HIRDLS

HIGH RESOLUTION DYNAMICS LIMB SOUNDER

Subject / Title: **Responses to Critical Design Review RFA's**

Project:	Earth Observing System
Spacecraft(SC/GS/LV):	CHEMISTRY
Instrument:	HIRDLS
Review:	CDR
Date:	Apr. 27-29, 1999

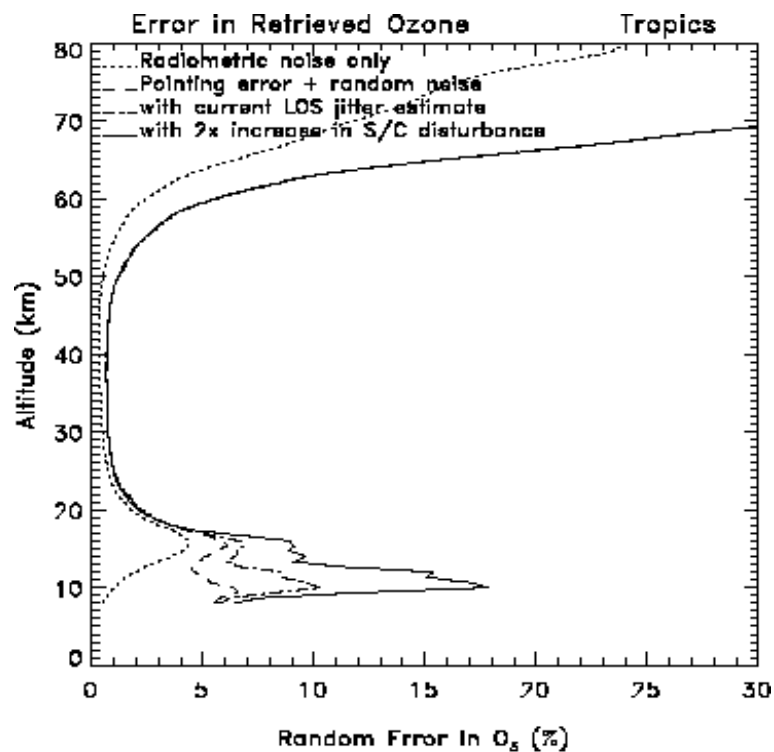
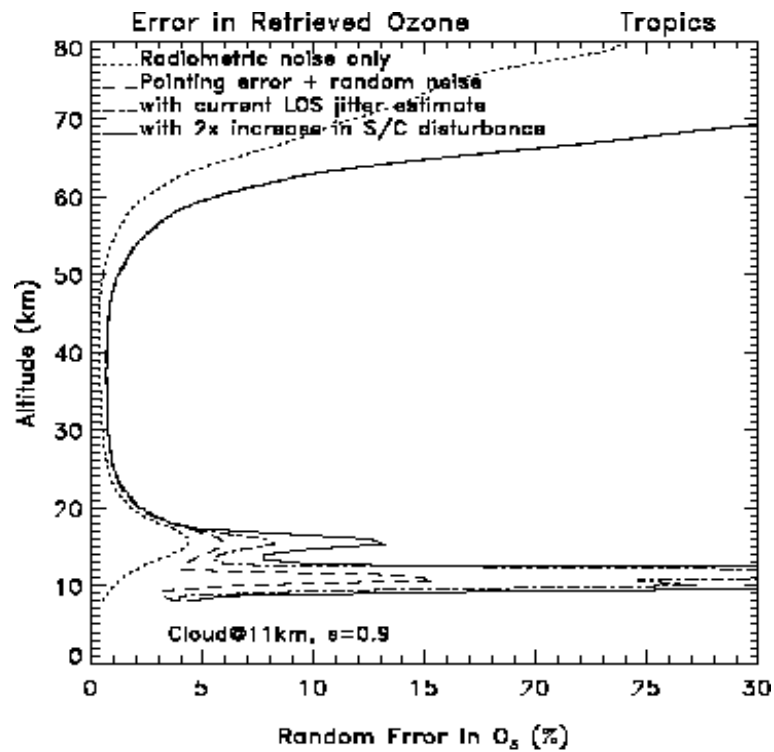
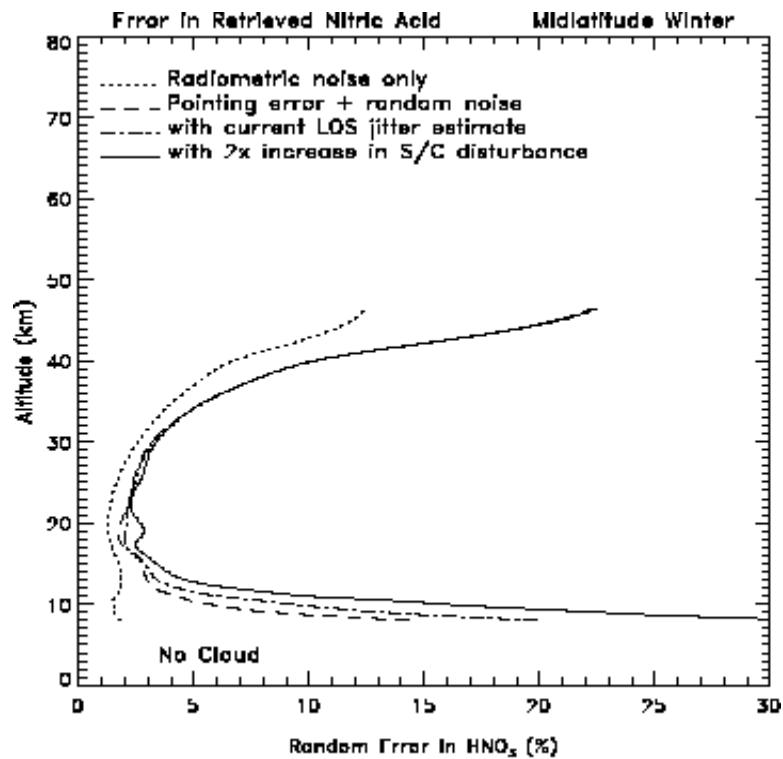
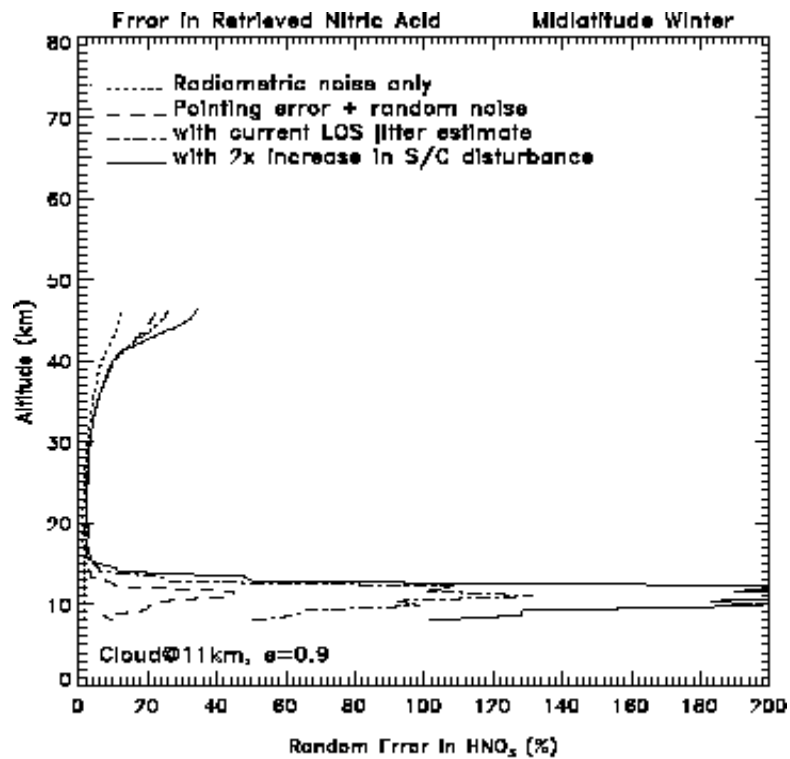
Describe the specific impacts to HIRDLS Level 1 Science requirements from disturbances due to spacecraft jitter. Enumerate completely and in detail the specific impacts to Level 1 Science requirements (not vague concerns).

The retrieval errors shown here were calculated using an estimate of mechanical disturbances at the HIRDLS baseplate arising from a number of sources including CHEM instruments and spacecraft solar array and reaction wheel assemblies. A power spectral density function defining the spacecraft disturbances was derived from data obtained from TRW (see HIRDLS technical memo TC-NCA-075). The HIRDLS line-of-sight (LOS) response to these disturbances was calculated using a model of the instrument transmissibility. The resultant LOS spectral response was converted to a time series of random LOS motions. These random motions were applied to radiance profiles (as a function of altitude), calculated for each of the HIRDLS channels, to generate time varying radiance signals. The radiance signals were then passed through a simulation of the instrument signal-processing chain to determine the radiometric measurement errors. Finally, the radiometric errors were combined with retrieval sensitivity matrices derived
